Access Compliance Report Public Rights-of-Way (Curb Ramps)

Main Street: SIENNA_PKWY Cross Street: DORRANCE_DR Location: N

ADA ID: RPRK211110130507 Ramp Type: Type 1 - Perpendicular Initial Pass/Fail: Pass Overall Compliance: No Severity Score: 16

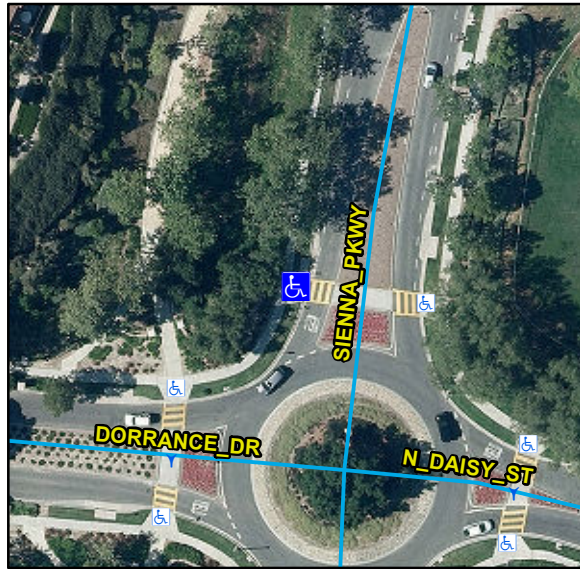
Compliance	Description	Data	Compliance	Description	Data
N/A	Ramp Length (in)	86	N/A	Flare Type LT	
Yes	Ramp Width (in)	48			Sloped
Yes	Ramp Run Slope (%)	7.6	N/A	Flare Slope LT (%)	11.3
Yes	Ramp Cross Slope (%)	0.9	N/A	Flare Traversable LT	No
N/A	Landing Present	Yes	N/A	Flare Type RT	
N/A	Landing Length (in)	63			Sloped
Yes	Landing Width (in)	48	N/A	Flare Slope RT (%)	8.5
No	Landing Run Slope (%)	3.9	N/A	Flare Traversable RT	No
Yes	Landing Cross Slope (%)	0.1	No	DWS Provided	No
N/A	Landing Movement Obstructed?	No	N/A	DWS Contrast	N/A
	Landing Movement Type	N/A	N/A	DWS Length (in)	N/A
N/A	Landing Shared	No	N/A	DWS Full Width	N/A
N/A	Clear Space	N/A	N/A	DWS Offset Left (in)	N/A
N/A	Clear Space To Crosswalk (in)	N/A	N/A	DWS Offset Right (in)	N/A
N/A	Marked Crosswalk 1	Yes	N/A	Marked Crosswalk 2	N/A
	Crossing 1 Direction	SE		Crossing 2 Direction	N/A
	Marked Crosswalk 1 Width (in)	144		Marked Crosswalk 2 Width (in)	N/A

Yes	Ramp Inside Crosswalk 1	Yes	Yes	Ramp Inside Crosswalk 2	N/A
	Crossing 1 Slope (%)	2.6		Crossing 2 Slope (%)	N/A
	Crossing 1 Cross Slope (%)	1.8		Crossing 2 Cross Slope (%)	N/A
Yes	Gutter Ponding	No	No	Curb Slope	11.7
Yes	Gutter Lip Height (in)	0		Road Run Slope (%)	N/A
No	Gutter Run Slope (%)	7.6		Road Cross Slope (%)	N/A
No	Gutter Cross Slope (%)	2.9			
Yes	Overall Surface Condition: Acceptable		No	Perp Joint Present	No
	Cross Gutter Present?	No		Spandrel Present?	No
	Replace Cross Gutter?	N/A		Replace Spandrel?	N/A

Remove & Replace Entire Ramp. Remove & Replace Gutter.
